# Sydney Harbour Bridge Cycleway Northern Access proposal

Response to submissions report  
August 2023

Figure 4-1: Overview of changes to the proposal

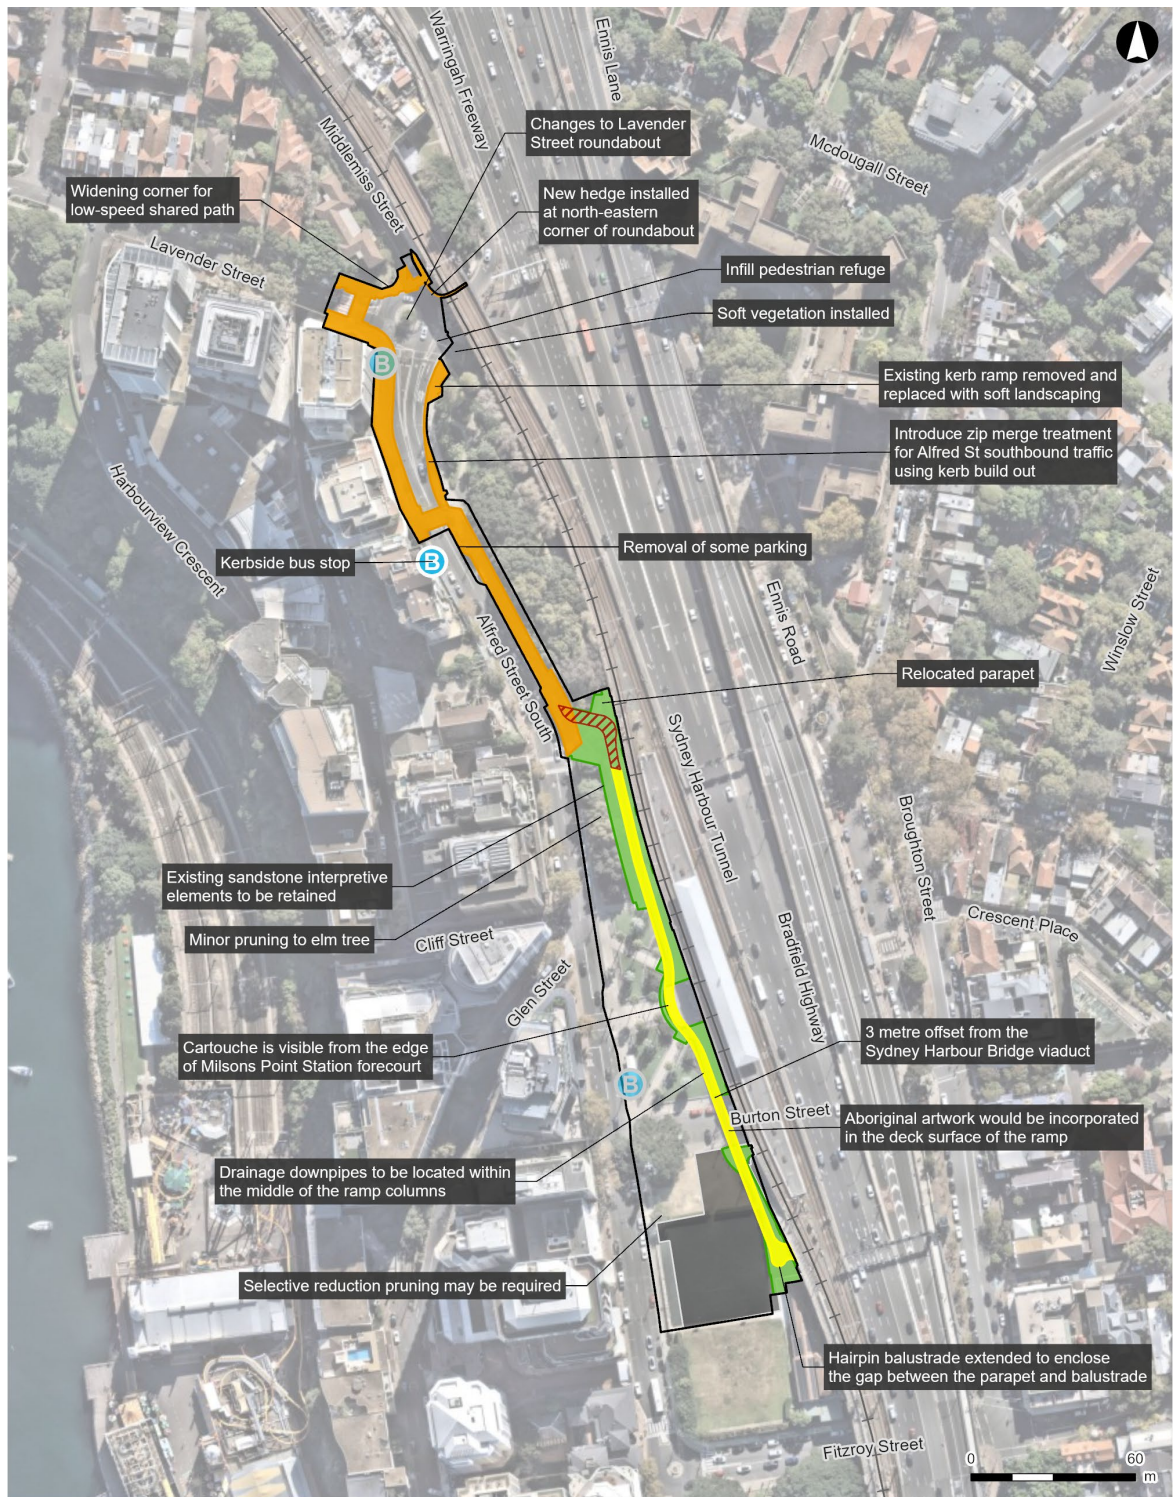
Figure 4-1 show key features of the revised design for the proposal. Further detail is provided in Figure 4-4 and Figure 4-5, which figures identify changes proposed to the elevated linear bike ramp, the bike ramp landing, and Alfred Street South cycle path.

Figure 4-4 Bike ramp landing – refined design

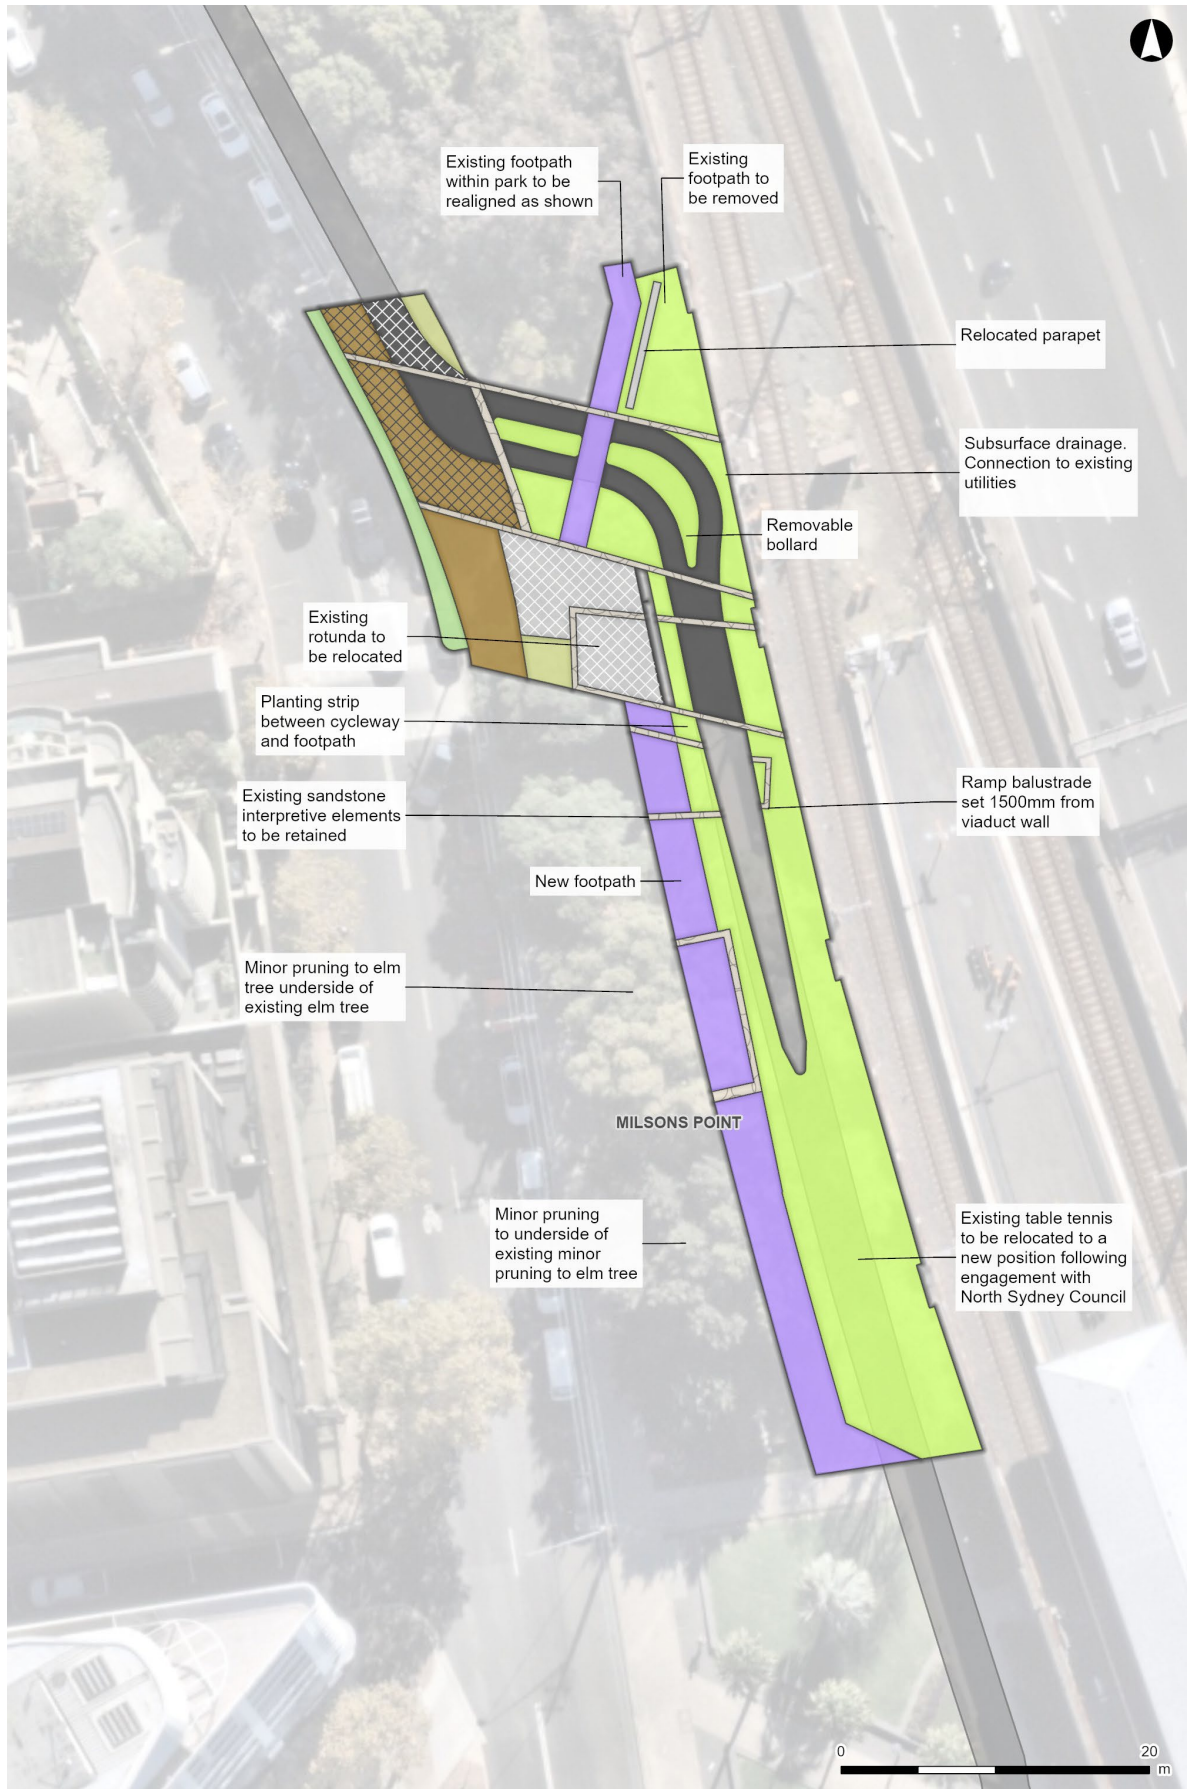
The ramp landing is about 85 metres north of Milsons Point Station entrance. As outlined in Chapter 4 of this submissions report, the parapet would be relocated in line with the new cycle path at the end of the landing point and would be subject to heritage interpretation (Figure 4-4).

Further surveys carried out in the proposal area confirmed the location of the sandstone inlays within Bradfield Park North. These elements would be retained as much as practical to minimise impacts to existing elements within Bradfield Park North.

Figure 4-5: Proposed adjustments to the Lavender Street roundabout

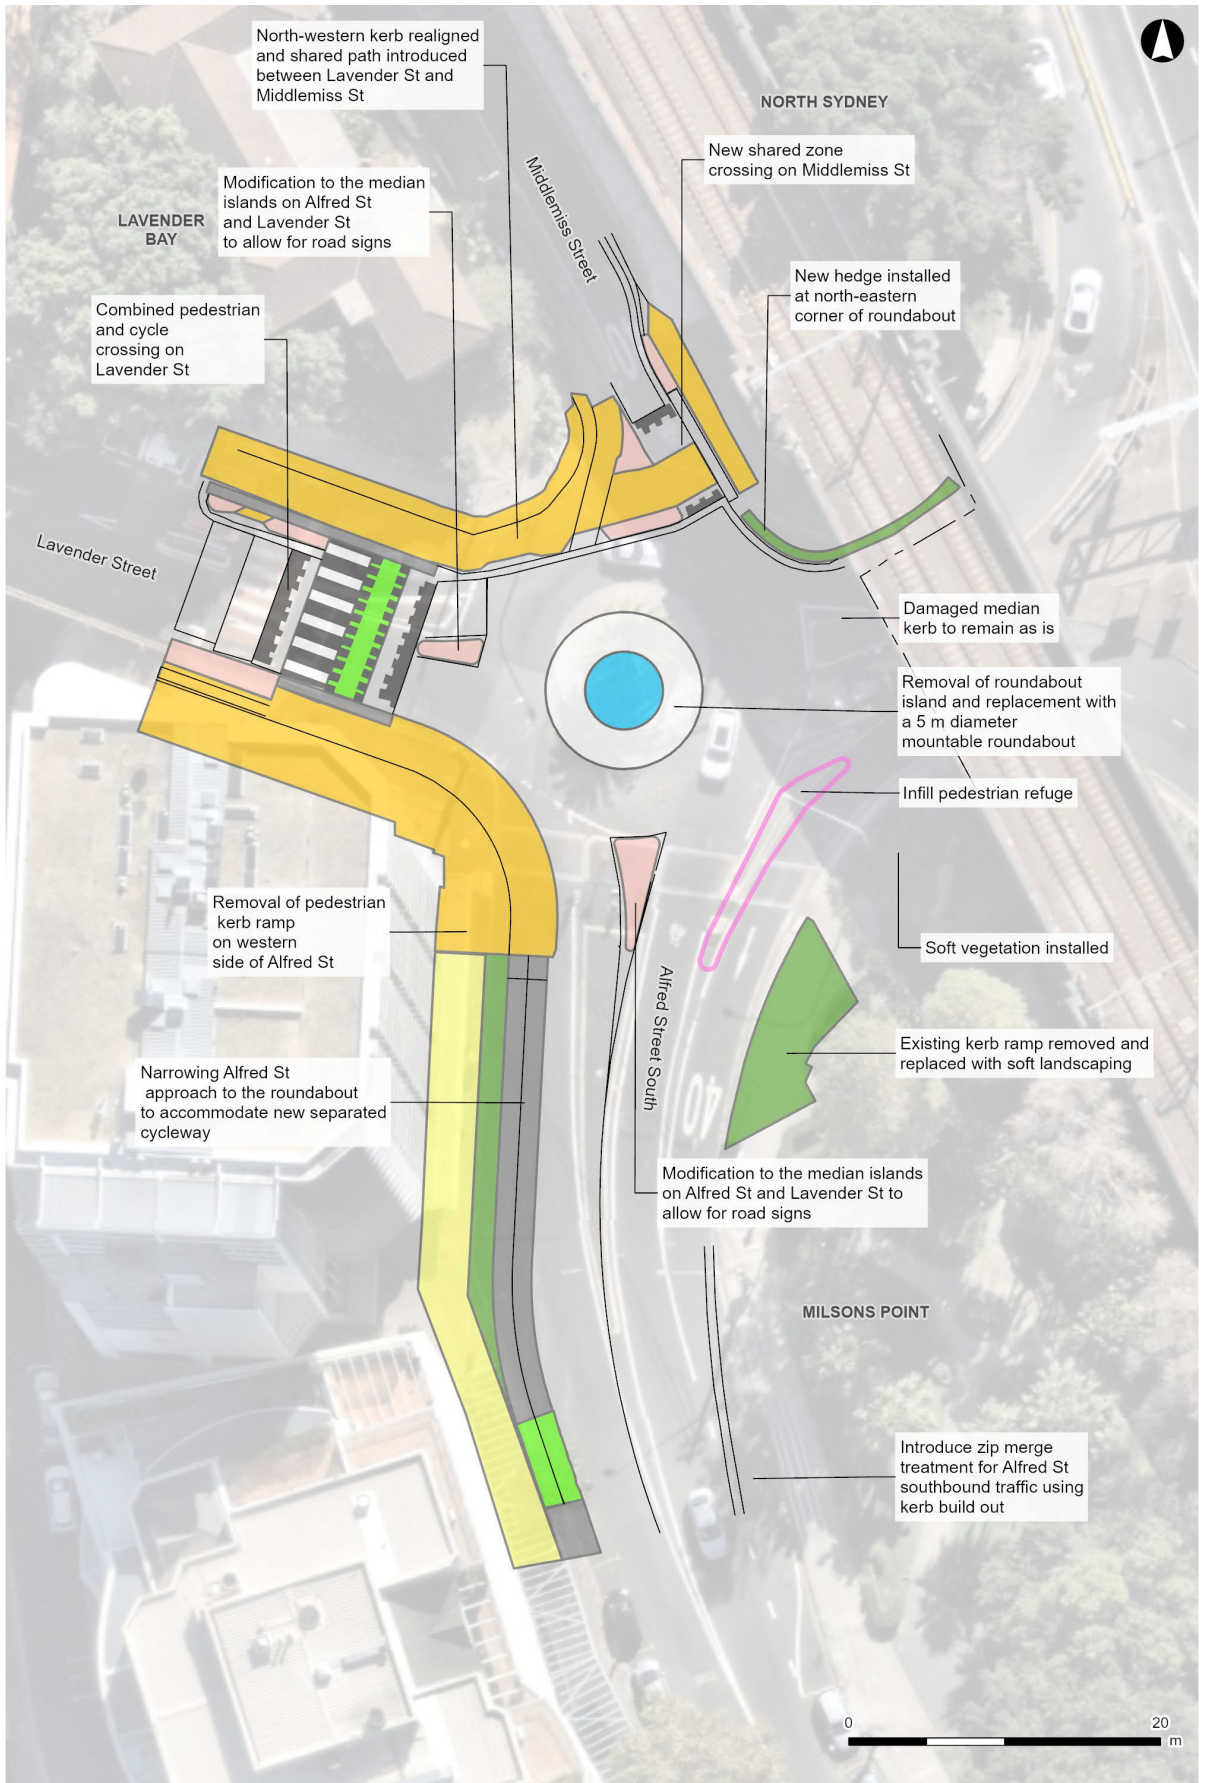
- The median kerb on the eastern side of the roundabout would be maintained.

The updated design for the Lavender Street roundabout is shown in Figure 4-3.

Figure 5-4: Trees proposed to be removed and pruned by the proposal

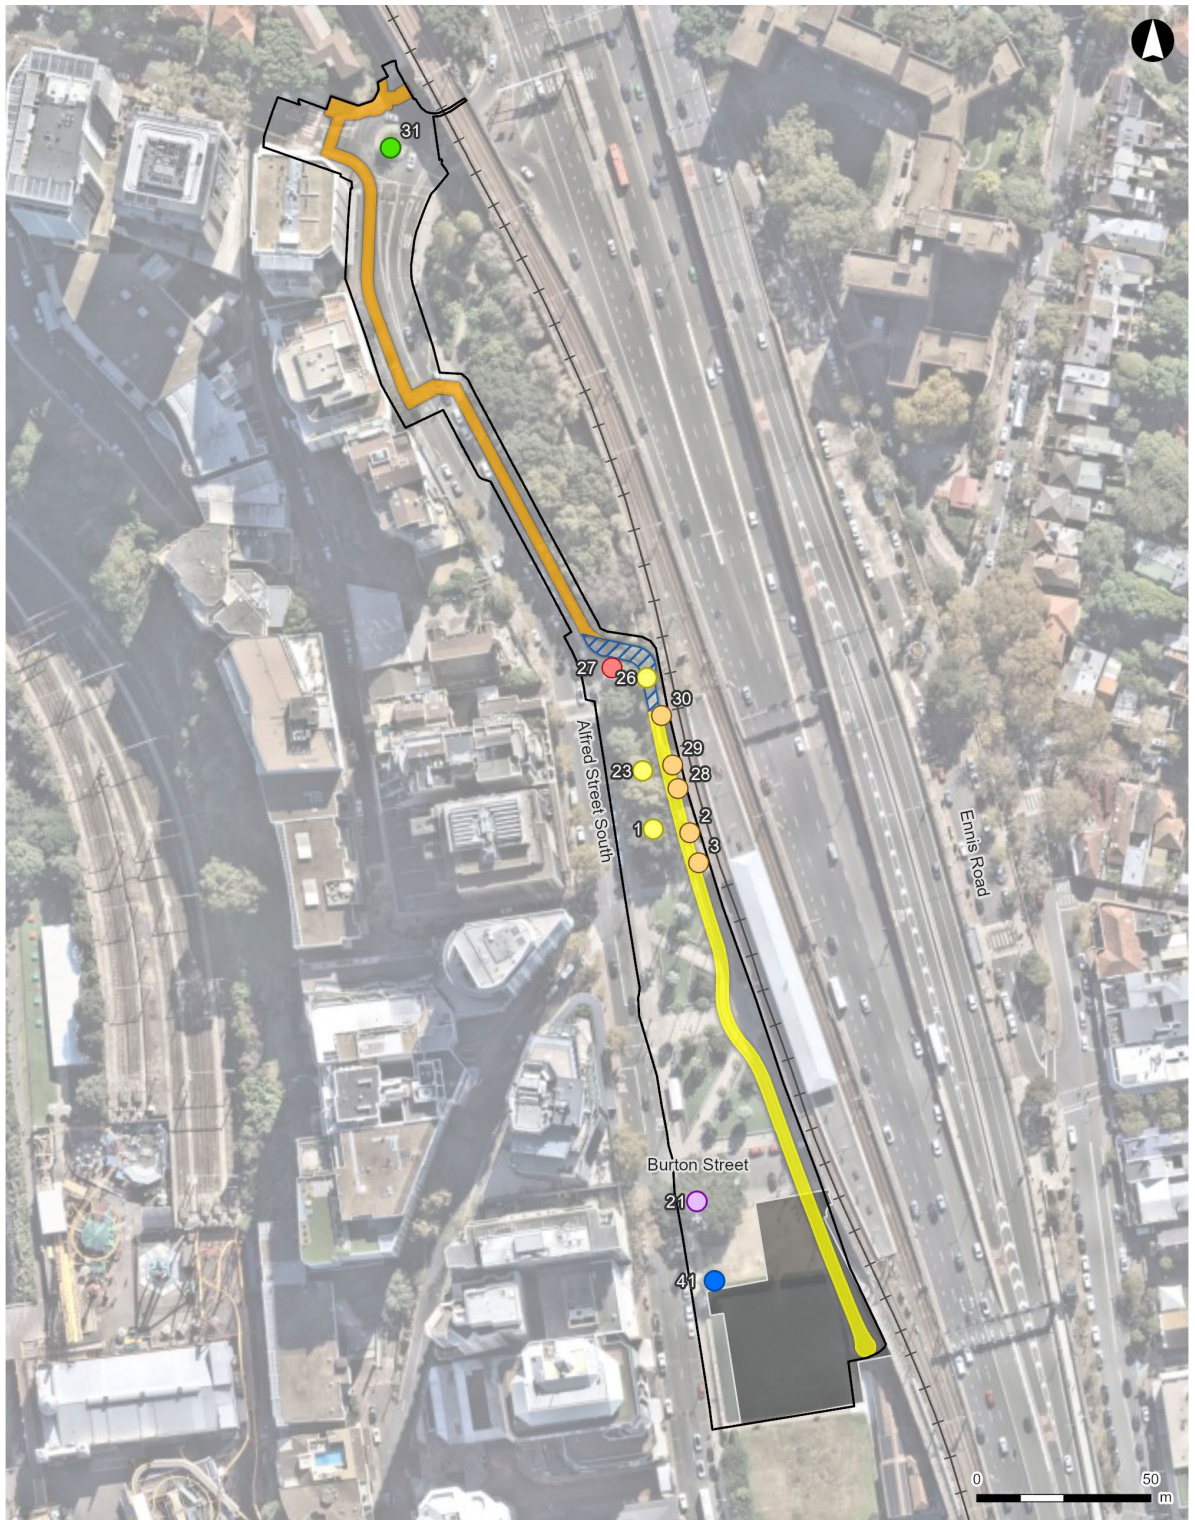
The proposed removal of Tree numbers 2, 3, 27, 28, 29, 30 and 31 remain consistent with section 6.7.3 of the REF.

In addition to Trees 1, 21 and 23 proposed for retention and pruning in the REF, the Arboricultural Impact Assessment has identified the following trees would require pruning to provide clearance to the elevated cycleway and for access during construction:

The trees proposed to be removed and pruned are shown in Figure 5-4.
